SUNDRY NOTICES AND REPORTS ON WELLS
Do not use this form for proposals to drill or to re-drill an abandoned well. Use form 3160-3 (APD) for such proposals.

1. Type of Well <input checked="" type="checkbox"/> Oil Well <input type="checkbox"/> Gas Well <input type="checkbox"/> Other		7. If Unit or CA/Agreement, Name and/or No.
2. Name of Operator BTA OIL PRODUCERS		8. Well Name and No. MESA 8105 JV P 18H
3a. Address 104 SOUTH PECOS STREET MIDLAND, TX 79701		9. API Well No. 30-025-42853-00-X1
3b. Phone No. (include area code) Ph: 432.682.3753		10. Field and Pool or Exploratory Area JENNINGS
4. Location of Well (Footage, Sec., T., R., M., or Survey Description) Sec 1 T26S R32E SESE 310FSL 1294FEL		11. County or Parish, State LEA COUNTY, NM

PECOS DISTRICT CONDITIONS OF APPROVAL

OPERATOR'S NAME:	BTA Oil Producers, LLC
LEASE NO.:	NMNM-14492
WELL NAME & NO.:	Mesa 8105 JV-P 18H
SURFACE HOLE FOOTAGE:	0310' FSL & 1294' FEL
BOTTOM HOLE FOOTAGE	0230' FNL & 1294' FEL
LOCATION:	Section 01, T. 26 S., R 32 E., NMPM
COUNTY:	Lea County, New Mexico

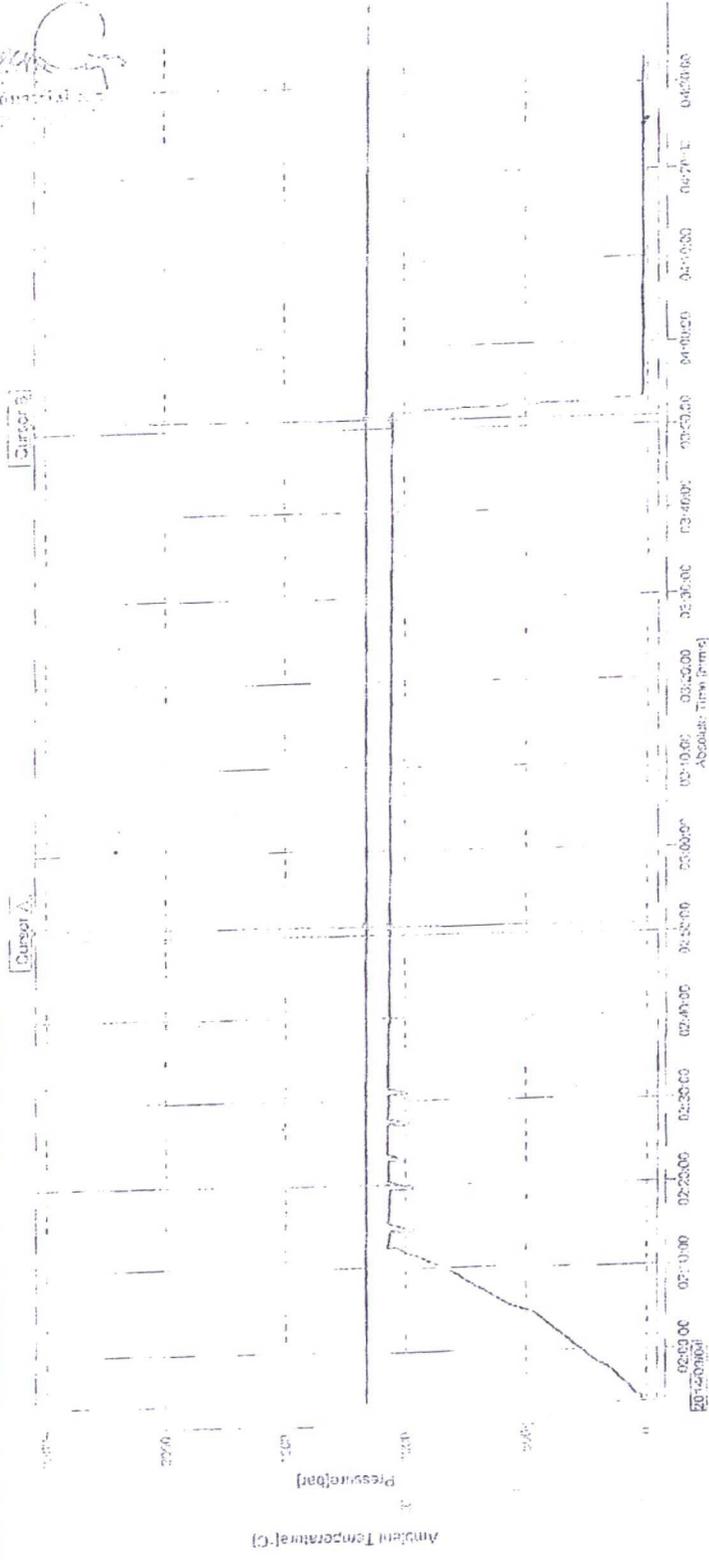
Choke Hose
-See attached for test chart and specs.

1. Variance approved to use flex line from BOP to choke manifold. Check condition of flexible line from BOP to choke manifold, replace if exterior is damaged or if line fails test. Line to be as straight as possible with no hard bends and is to be anchored according to Manufacturer's requirements. The flexible hose can be exchanged with a hose of equal size and equal or greater pressure rating. **Anchor requirements, specification sheet and hydrostatic pressure test certification matching the hose in service, to be onsite for review. These documents shall be posted in the company man's trailer and on the rig floor.** If the BLM inspector questions the straightness of the hose, a BLM engineer will be contacted and will review in the field or via picture supplied by inspector to determine if changes are required (operator shall expect delays if this occurs).

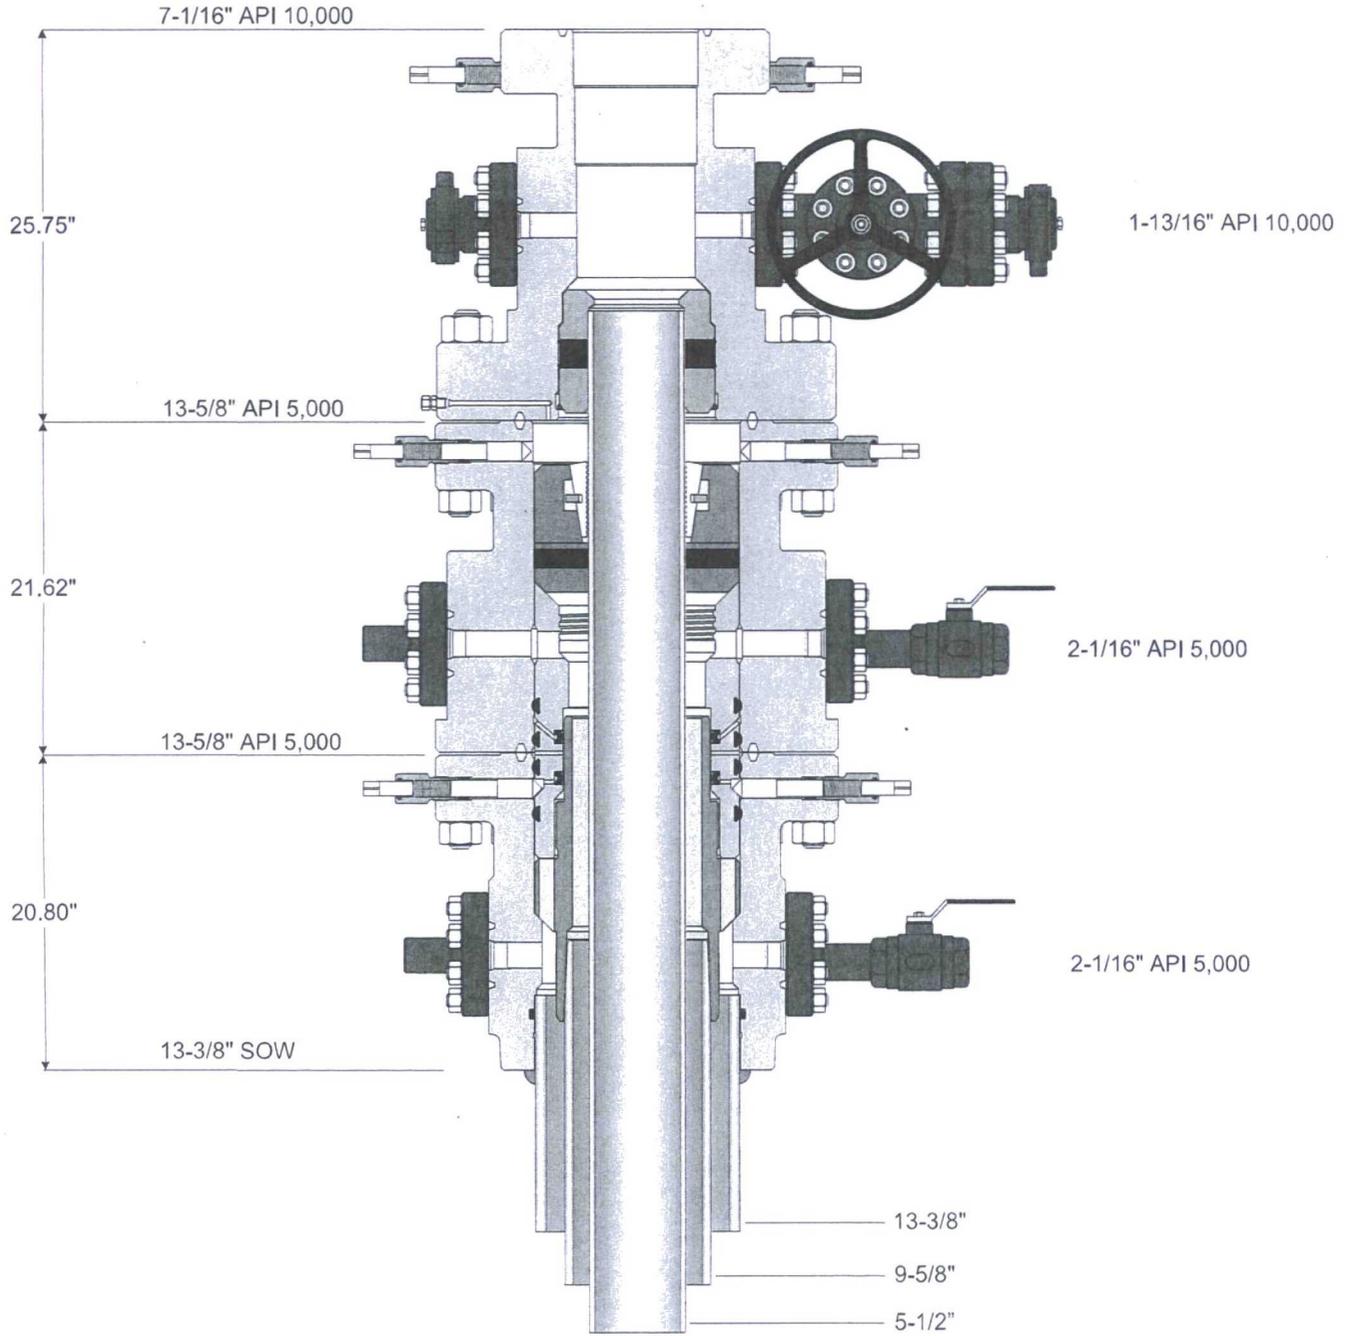
Multi Bowl Wellhead
-Wellhead will be installed on a 13-3/8" casing and tested to onshore order #2.
-See attached schematic and running procedure.

2. **Operator has proposed a multi-bowl wellhead assembly. This assembly will only be tested when installed on the surface casing. Minimum working pressure of the blowout preventer (BOP) and related equipment (BOPE) required for drilling below the surface casing shoe shall be 3000 (3M) psi.**

- a. **Wellhead shall be installed by manufacturer's representatives, submit documentation with subsequent sundry.**
 - b. **If the welding is performed by a third party, the manufacturer's representative shall monitor the temperature to verify that it does not exceed the maximum temperature of the seal.**

- c. **Manufacturer representative shall install the test plug for the initial BOP test.**
 - d. **If the cement does not circulate and one inch operations would have been possible with a standard wellhead, the well head shall be cut off, cementing operations performed and another wellhead installed.**
